Product Change Notification / KSRA-15BCAH919

CCB 4437 Final Notice: Implement MMT shipping tube for selected AT27xxxx, AT28xxxx and SST39xxxx products available in 32L PLCC package.

**KSRA-15BCAH919
CCB 4437**

Shipping Tube Pre and Post Change

❑ Tube Comparison (AT27xxxx and AT28xxxx Products):

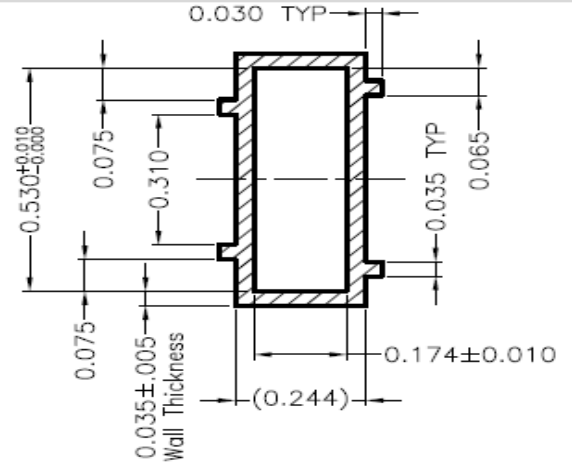
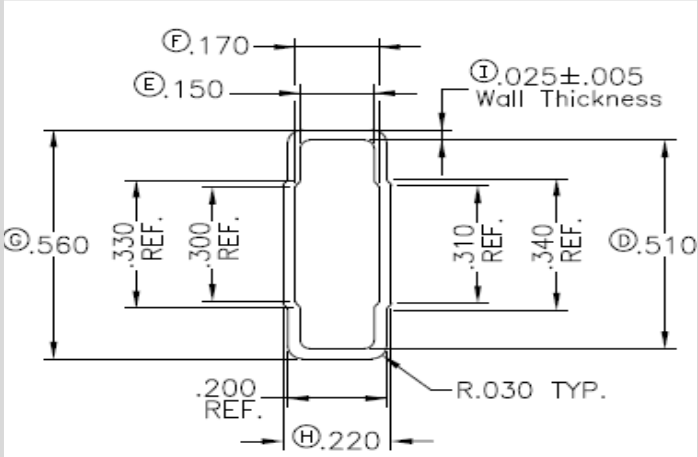
Pre change	Post change
Tube Dimension	
<p>Length: 20.40+/-0.10 inch Width: 0.600+0.015/-0.005 inch Tube Opening Length (A): 0.174 + 0.010 inch Tube Opening Width (B): 0.530+0.010/-0.000 inch Wall thickness (T): 0.035 + 0.005 Tube Opening:</p>	<p>Length: 21.70 ± 0.045 inch Width: 0.560 ± 0.015 inch Tube Opening Length (A): 0.170 ± 0.010 inch Tube Opening Width (B): 0.510 ± 0.010 inch Wall thickness (T): 0.025 ± 0.005 inch Tube Opening:</p>

❑ Tube Comparison (SST39xxxx products):

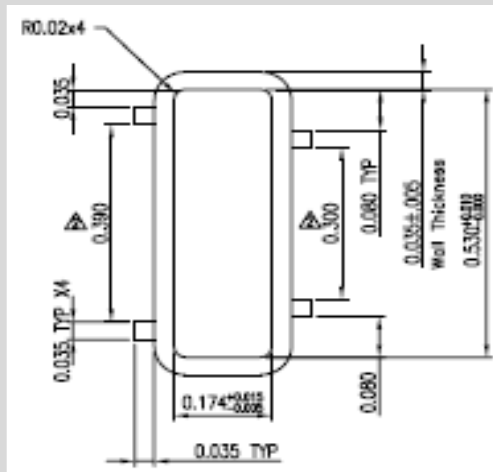
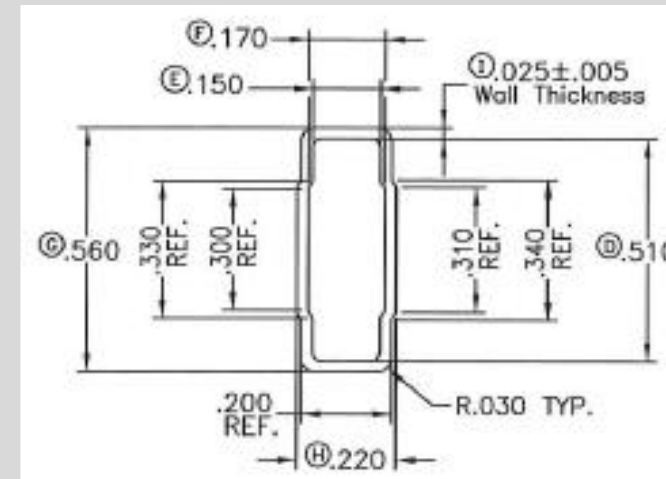
Length: 19.40+/-0.05 inch
Width: 0.600+0.015/-0.005 inch
Tube Opening Length (A): 0.174+0.010/-0.005 inch
Tube Opening Width (B): 0.530+0.010/-0.000 inch
Wall thickness (T): 0.035 ± 0.005

Length: 20.02 ± 0.05 inch
Width: 0.560 ± 0.015 inch
Tube Opening Length (A): 0.170 ± 0.010 inch
Tube Opening Width (B): 0.510 ± 0.010 inch
Wall thickness (T): 0.025 ± 0.005 inch

For SST39xxxx products

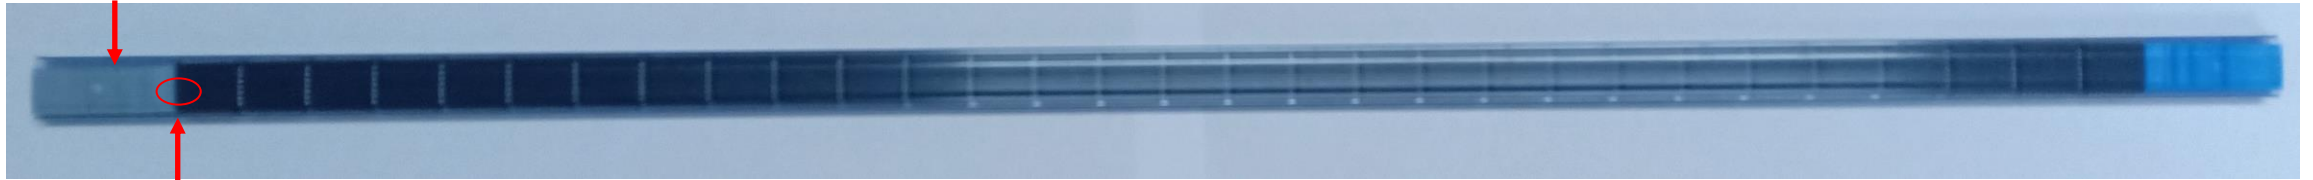
Tube Stopper

Blue and white colored stopper

Blue and gray colored stopper
